EMBER Bushfire Consulting

Subject: Addendum to Bush Fire Strategic Study - Amendments to the Googong Foreshore Interface Management (GFIMS) Planning Proposal.

This addendum should be read in conjunction with the original Bush Fire Strategic Study, "Bush Fire Assessment Report—Googong Planning Proposal," JD.168.22, issued 12.7.2023.

Figure 2 - Proposed zone boundaries, conceptual layout and areas of change.

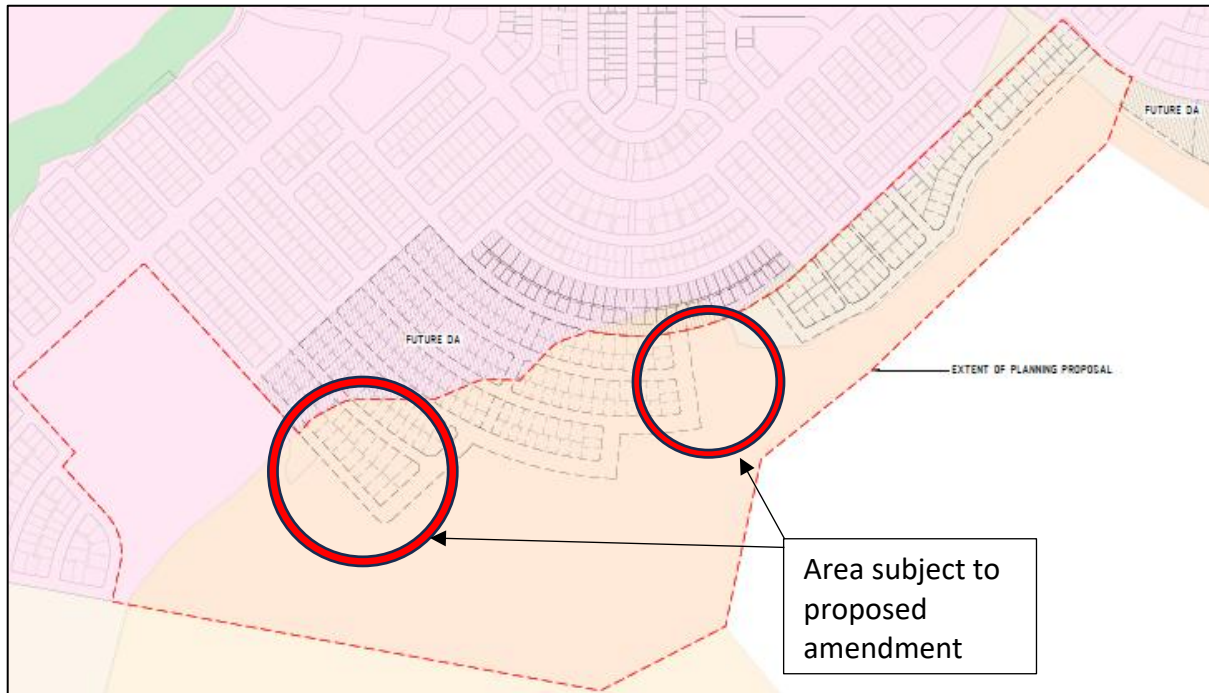
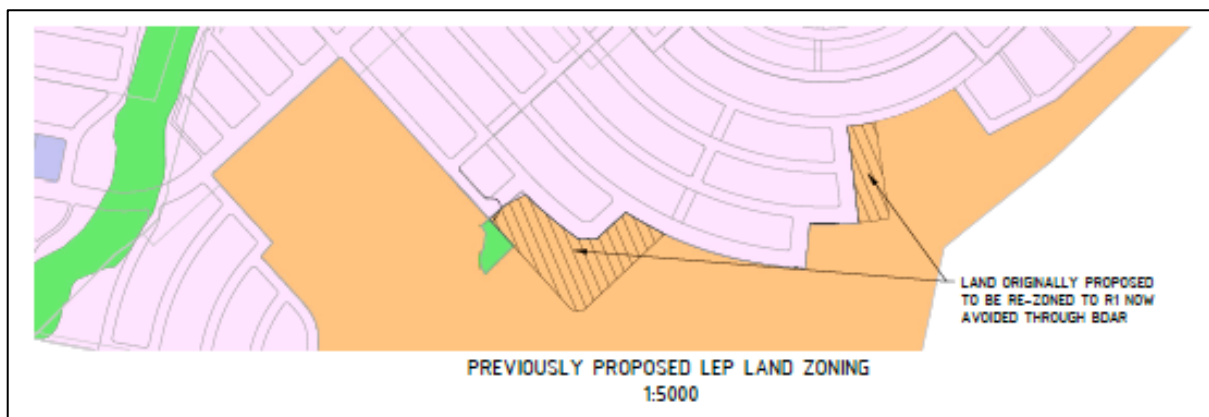
The proposed amendments (Figure 2) are minor, but they will bring the boundary inward and slightly reduce the overall footprint of the concept subdivision.

The boundary realignment does not alter the key parameters of the hazard assessment. The dominant hazard vegetation remains conservatively assessed as Woodland and Forest. The slope assessment in the modified areas also does not change, as the topography remains the same.

The broad design principles of the subdivision layout remain the same, with the same key bushfire protection measures incorporated into the design. A perimeter road skirts around future residential areas, providing compliant access arrangements and the necessary APZ setbacks to ensure adequate protection and compliance with PBP.

While the perimeter road width appears the same as in the original design, given its conceptual nature, adjustments are expected to be made to the detailed design during the DA phase of development to ensure compliance with PBP 2019.

Having reviewed the original report, the concept subdivision design, and the proposed minor changes, I am comfortable continuing to support the planning proposal. The proposal remains capable of meeting the underlying principles of strategic planning for bushfire protection and should, therefore, also be supported by the Council and RFS.
